24/00560/HYB – LAND SOUTH OF STATION ROAD, MARKET BOSWORTH

ADC Infrastructure Limited are commissioned by the applicant, Miller Homes, to provide transport and highways advice in support of a hybrid planning application for the construction of 138 residential dwellings and 0.55ha of employment use on land to the south of Station Road in Market Bosworth. The planning application was supported by a Transport Assessment and Travel Plans.

This letter has therefore been produced to present the updated vehicle tracking assessment and traffic calming features proposed to ensure suitable design speeds throughout the development.

Notes

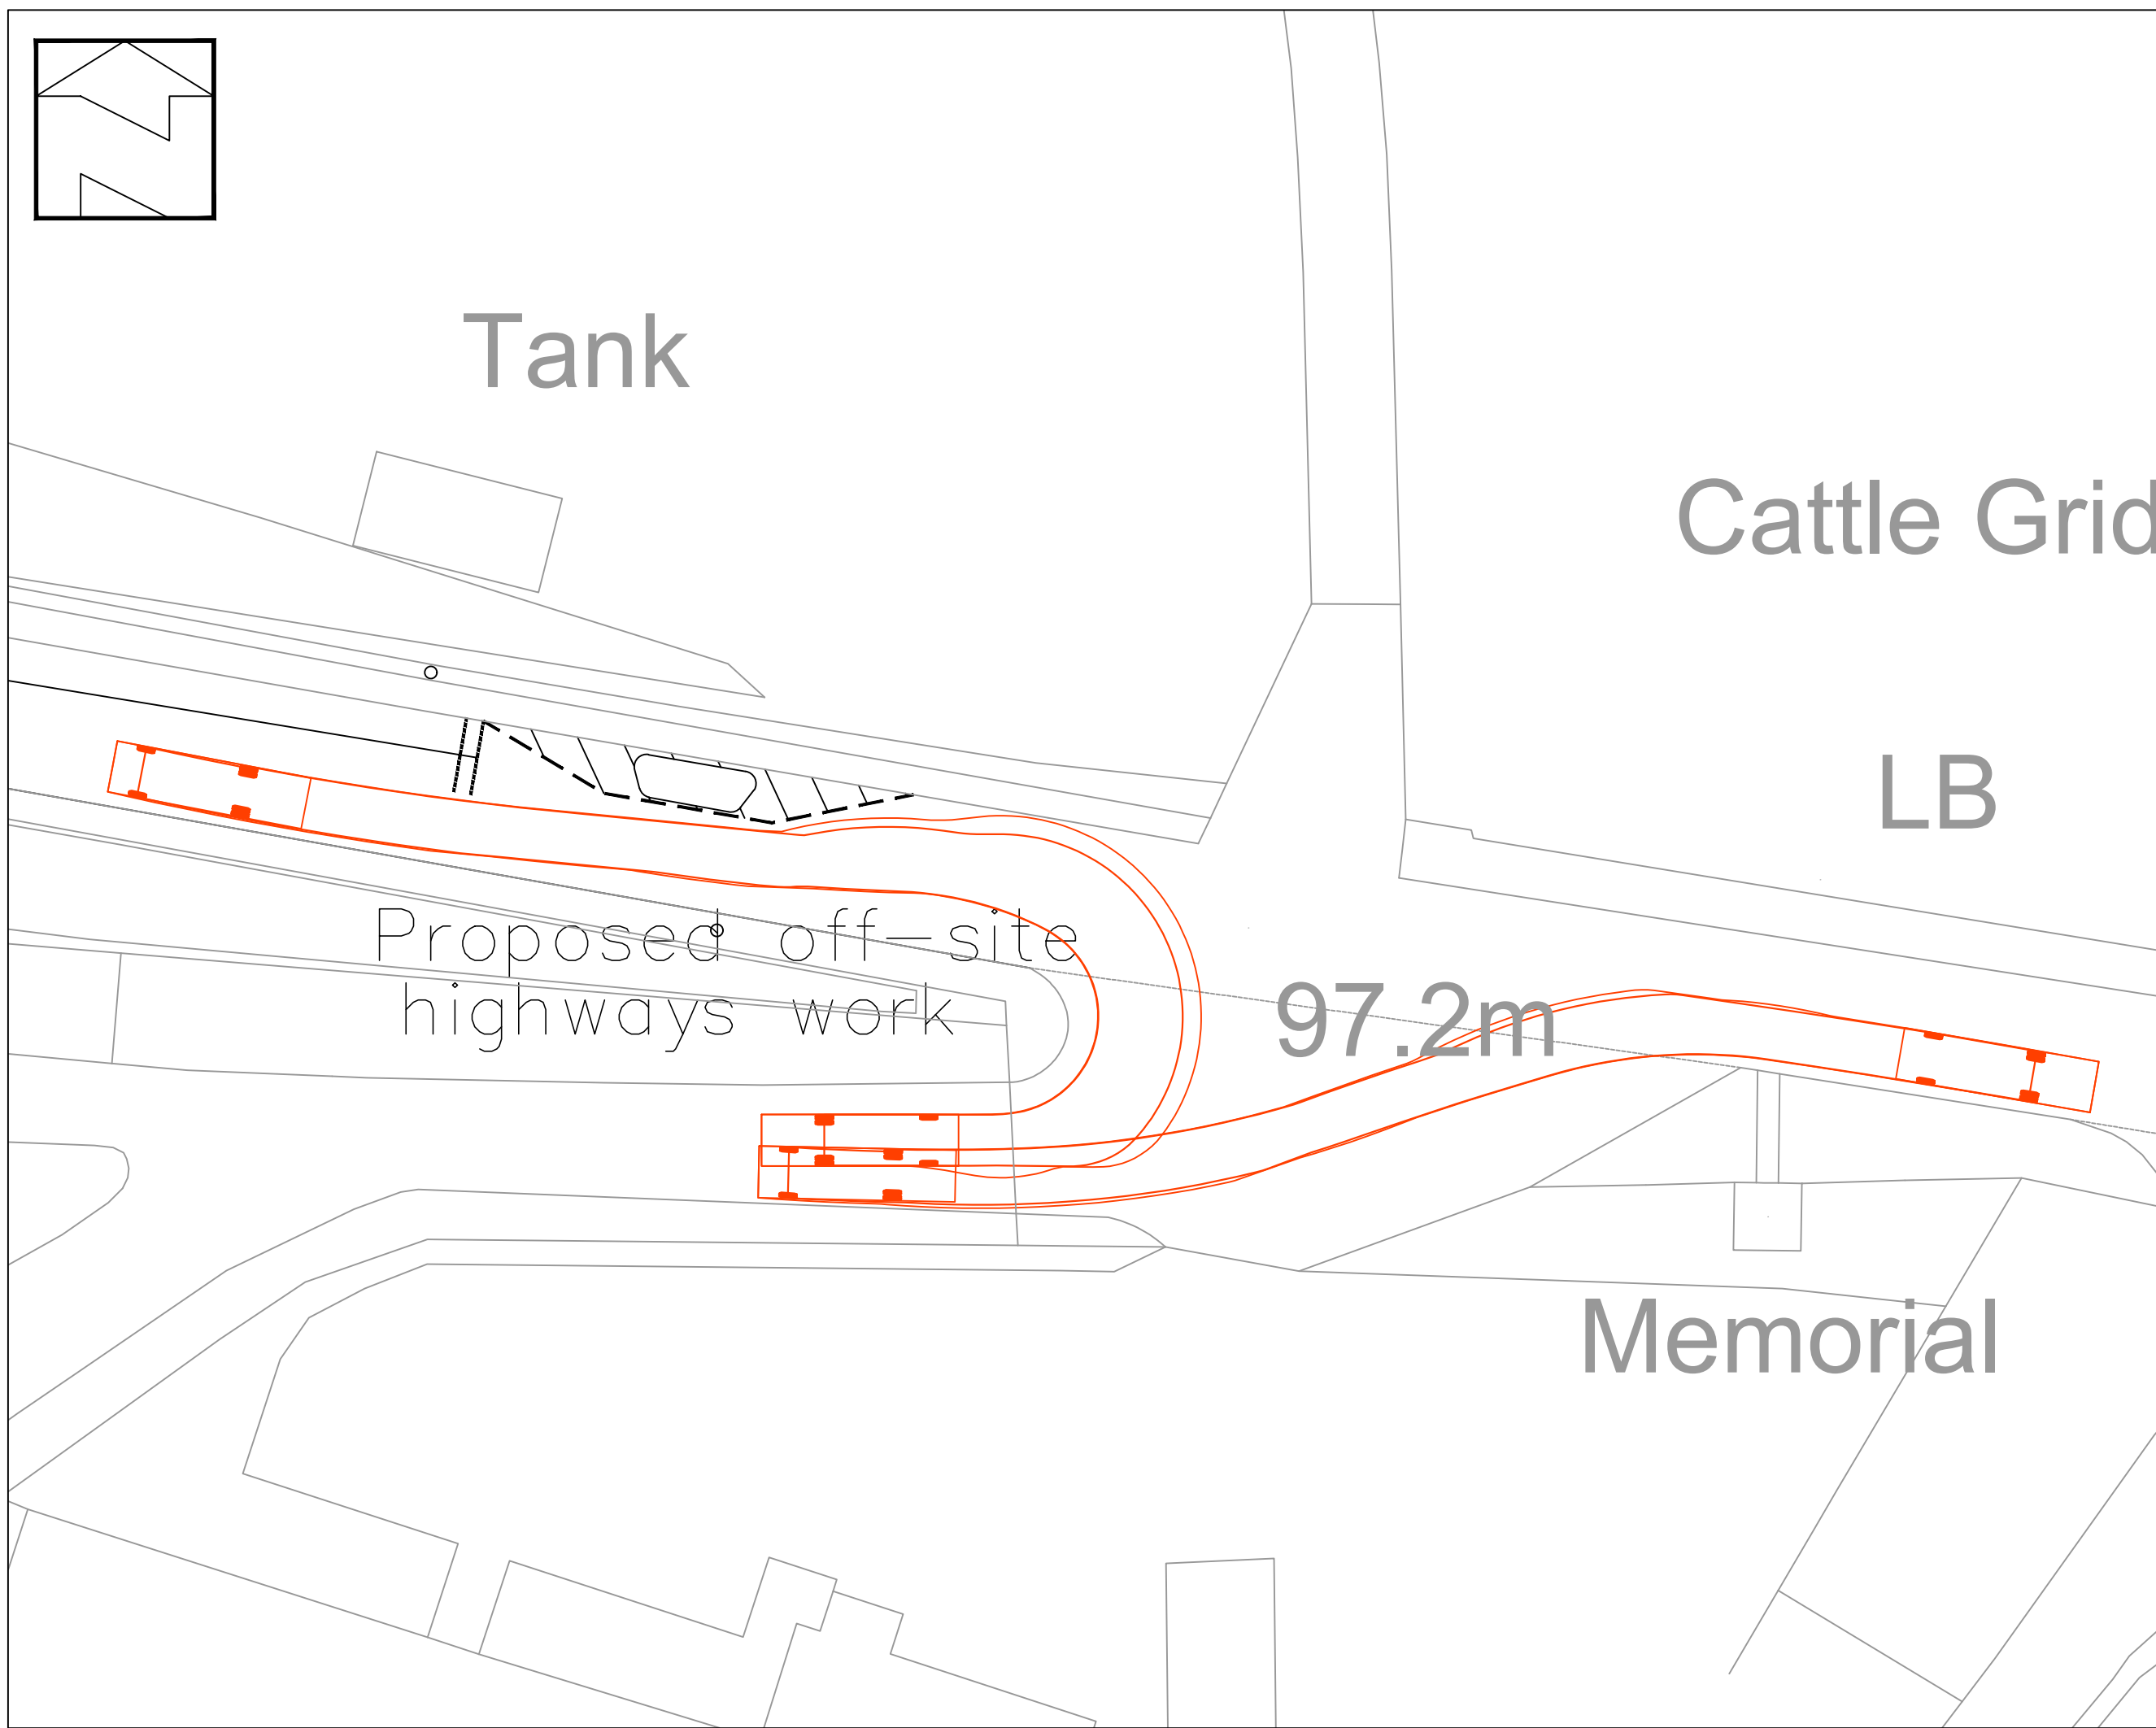
- Turning for a refuse vehicle has been shown, however the specification including the dimensions of the vehicle should be clarified and in line with the Swept Path Analysis guidance within the LHDG. This could be shorter than the 11.2m stated within the LHDG.

- The visibility splay looks to go over a tiny bit of third party land
- Changes will be needed to the swept path for refuse vehicles – it looked like the wrong size of vehicle had been used. This might affect the road layout and plot positions
- Traffic calming needed improving
- There remains an issue with the railway station access

Vehicle tracking of an 11.2m refuse vehicle has been undertaken. The vehicle tracking assessment is shown in **Drawing ADC3326-DR-005-P6** and demonstrates that the design vehicle can access, turn using the turning heads provided and exit again onto Station Road in a forward gear.

The drawing also demonstrates that the refuse vehicle can travel in both directions on the bends in the eastern parts of the development whilst opposed by a large car. As a result, the development layout is suitable to serve refuse and servicing vehicles.
